Rezoning Transportation Analysis

Petition Number: 2018-083

Revision Log:	Date	Description
	08-14-18	First Review

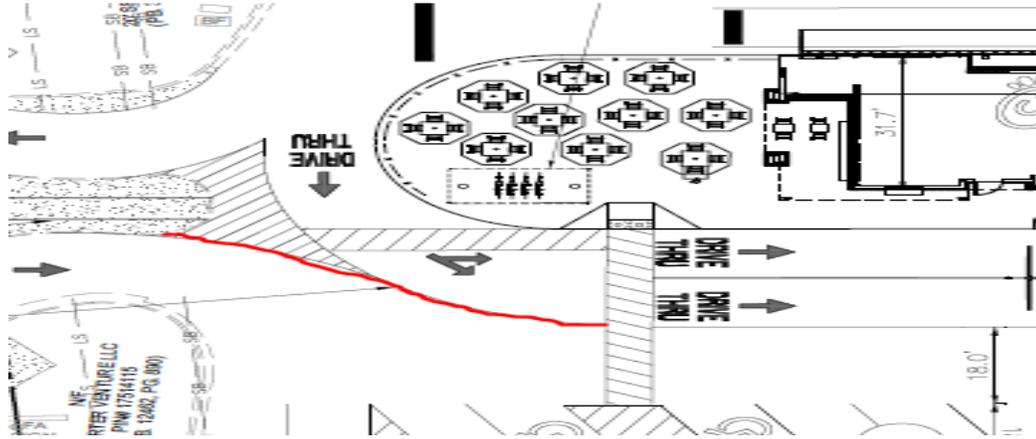
- Traffic Study** A Traffic Impact Study/Transportation Technical Memorandum is not necessary for the complete review of this petition.
- The petitioner should revise the site plan and conditional note(s) to show concrete median instead of "removable magnetic delineators" to prohibit vehicles from going straight into drive-thru line (see attached exhibit).
